# **OROVILLE DAM CITIZENS ADVISORY COMMISSION**

**Meeting 22  
April 10, 2026**

# **DOWNSTREAM PERSPECTIVE ON WATER CONTROL MANUAL**

**WATER CONTROL MANUAL UPDATES  
A DOWNSTREAM PERSPECTIVE**  
Commissioners Bill Connelly and Robert Bateman  
April 10, 2026

Figure 3-3. FIRO Space for ORO Reservoir.

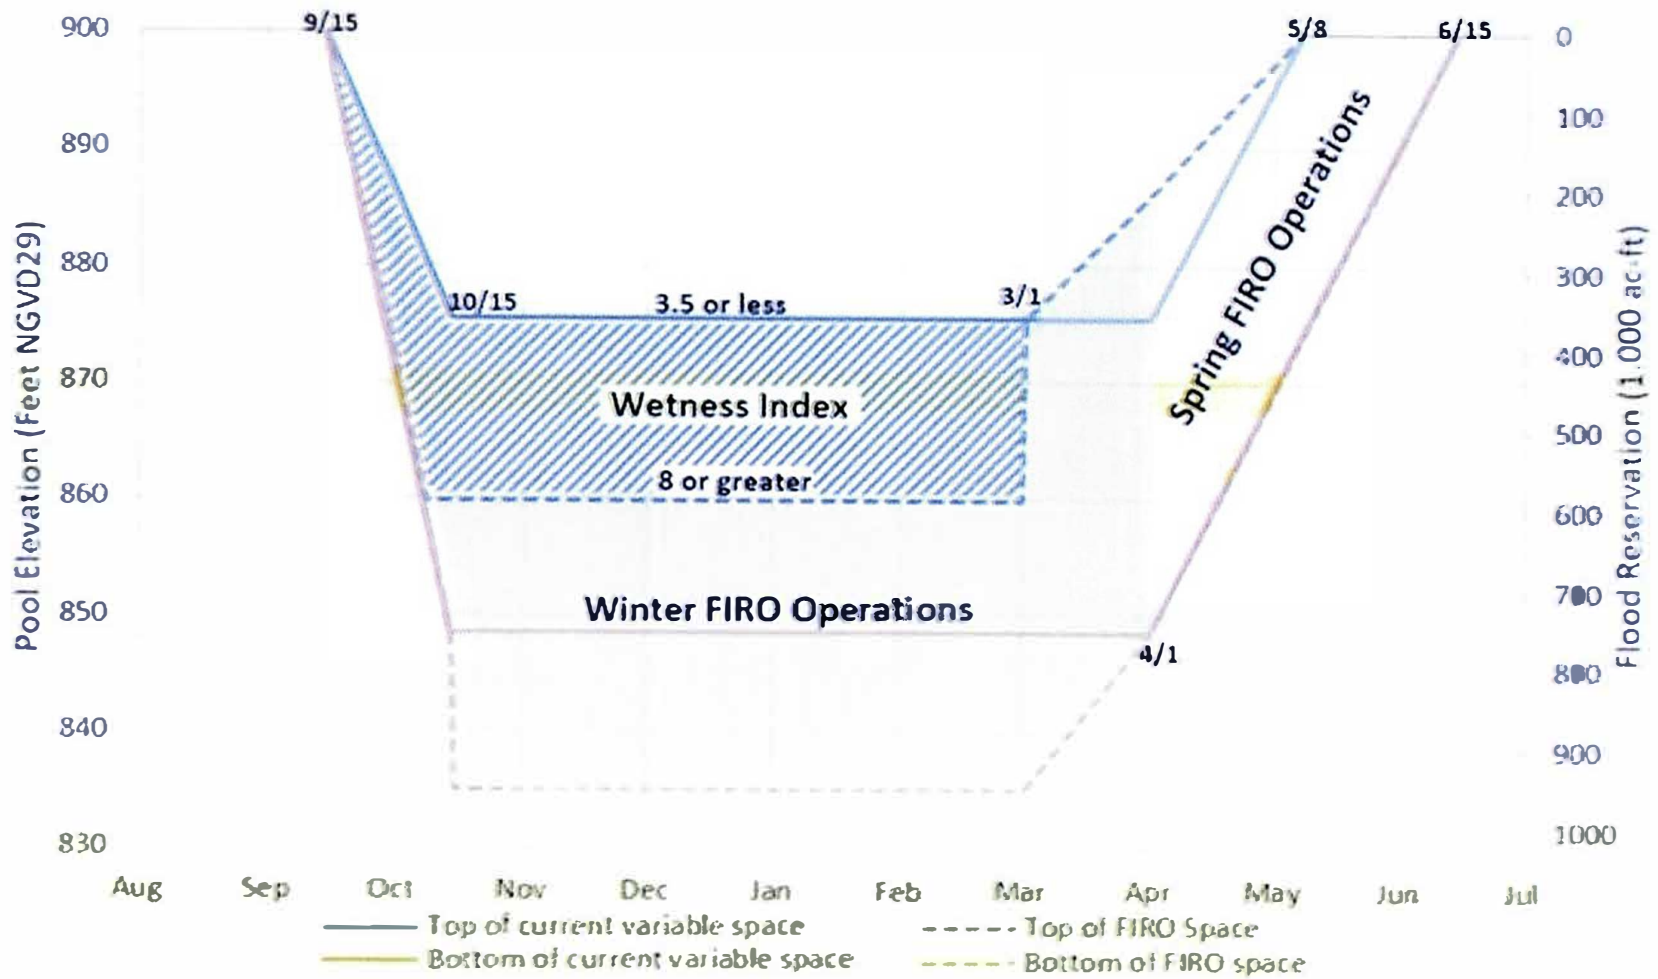
In specifying the parameters for the FIRO study, the DWR had a perverse influence

- Limiting the FIRO study to lowering the reservoir to 835 ft as opposed to the bottom of the gates which approximately doubled the theoretical risk of damaging floods
- Specifying that only an additional 200,000 acre feet of flood pool would be offered in the study during years of heavy precipitation but asked that the flood pool would be reduced in drought years by 400,000 acre feet. This is not consistent with the declared policy that safety would be the priority
- Not setting an “aspirational goal” for the amount of flood protection to be provided but did have a goal for the increase in the retention of water

A late January email from the deputy director of DWR stated that “**the DWR is looking to use FIRO to gain more flood management and water supply benefits from the existing flood reservation space.**” This eliminated FIRO plan ID4 which involves a variable flood pool. He added that with climate change the protection downstream communities can expect will decrease.

Thus, DWR “policy” has caused the FIRO studies to be flawed and removed the possibility of the WCM updates providing protection from the most severe storms that can be expected in the next 500 years while at the same time increasing water storage.
